Technical Service Bulletin: TSB101036

Field Notification of Mislabels QSK60 Phase 2.0 CENSE™ Wiring Diagram, Bulletin 4021412 (Version-02 and -03)

Figure 1: Wiring Diagram Changes

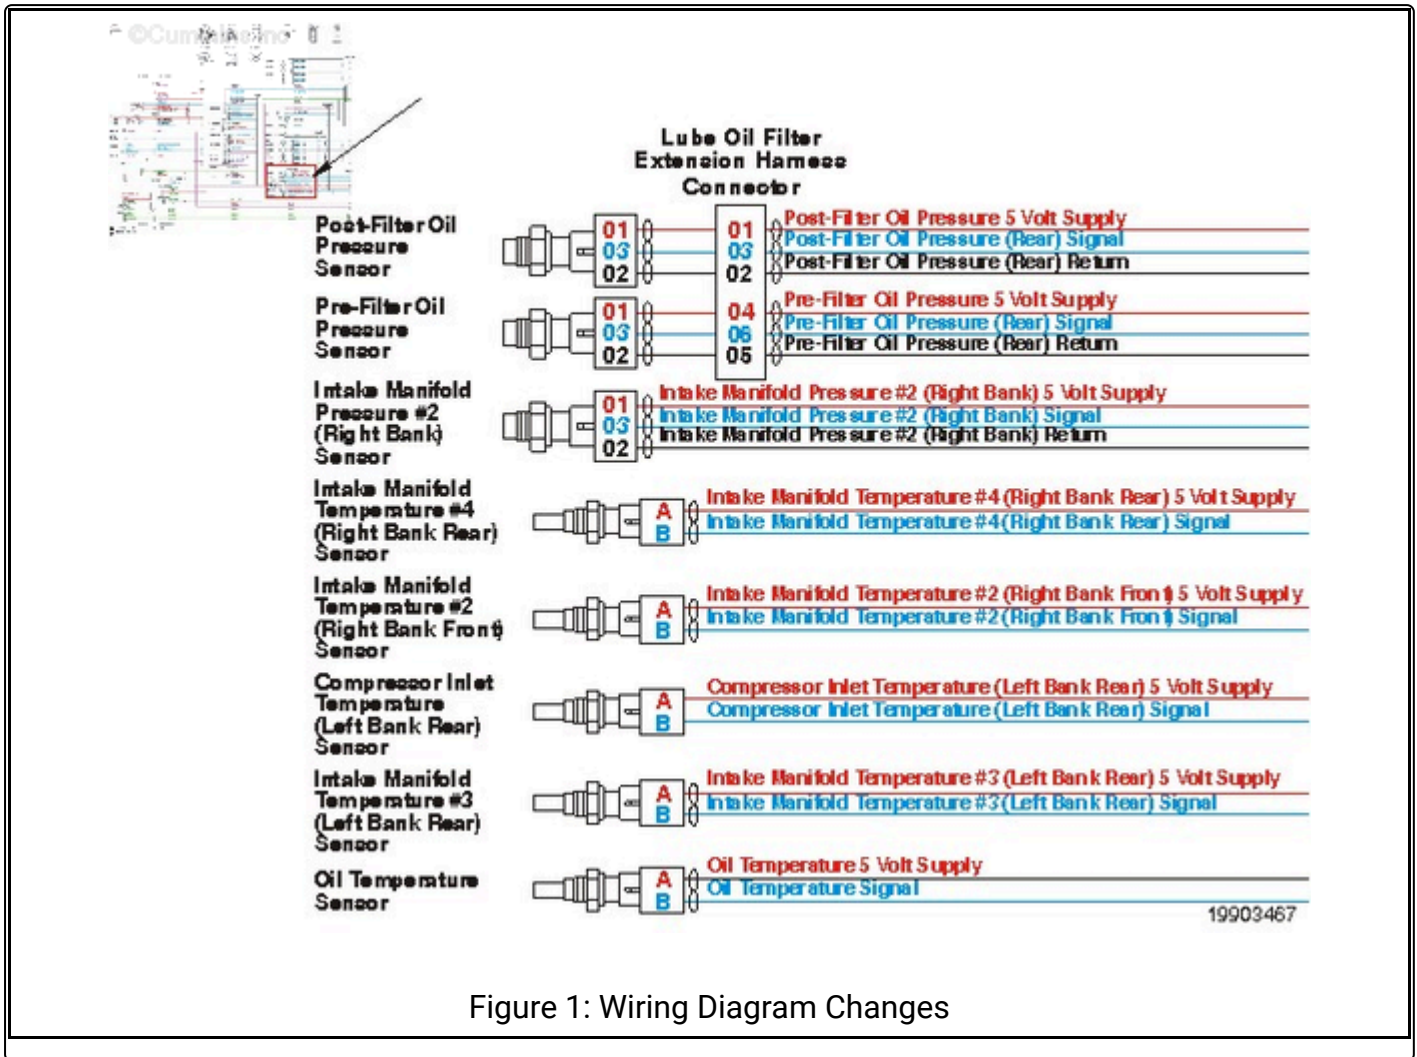
The purpose of this document is to inform the field of three sensor and six wire mislabels on the Lube Oil Filter Extension Harness Connector for the QSK60 Phase 2.0 Industrial with CENSE™ Wiring Diagram, Bulletin 4021412. These mislabels exist on two versions of the wiring diagram, Bulletin 4021412-02 and 4021412-03. Reference Table 1 and Table 2 for the intended label information until Bulletin 4021412-04 of the wiring diagram is available.

Sensor Mislabels	Intended Sensor Labels
Intake Manifold Temperature #3 (Right Bank Rear) Sensor	Intake Manifold Temperature #4 (Right Bank Rear) Sensor
Intake Manifold Temperature #3 (Right Bank Front) Sensor	Intake Manifold Temperature #2 (Right Bank Front) Sensor
Intake Manifold Temperature #2 (Left Bank Rear) Sensor	Intake Manifold Temperature #3 (Left Bank Rear) Sensor

Wire Mislabels	Intended Wire Labels
Intake Manifold Temperature #3 (Right Bank Rear) 5 Volt Supply	Intake Manifold Temperature #4 (Right Bank Rear) 5 Volt Supply
Intake Manifold Temperature #3 (Right Bank Rear) Signal	Intake Manifold Temperature #4 (Right Bank Rear) Signal

Table 2: Wire Labels from the Lube Oil Filter Extension Harness	
Wire Mislabels	Intended Wire Labels
Intake Manifold Temperature #3 (Right Bank Front) 5 Volt Supply	Intake Manifold Temperature #2 (Right Bank Front) 5 Volt Supply
Intake Manifold Temperature #3 (Right Bank Front) Signal	Intake Manifold Temperature #2 (Right Bank Front) Signal
Intake Manifold Temperature #2 (Left Bank Rear) 5 Volt Supply	Intake Manifold Temperature #3 (Left Bank Rear) 5 Volt Supply
Intake Manifold Temperature #2 (Left Bank Rear) Signal	Intake Manifold Temperature #3 (Left Bank Rear) Signal
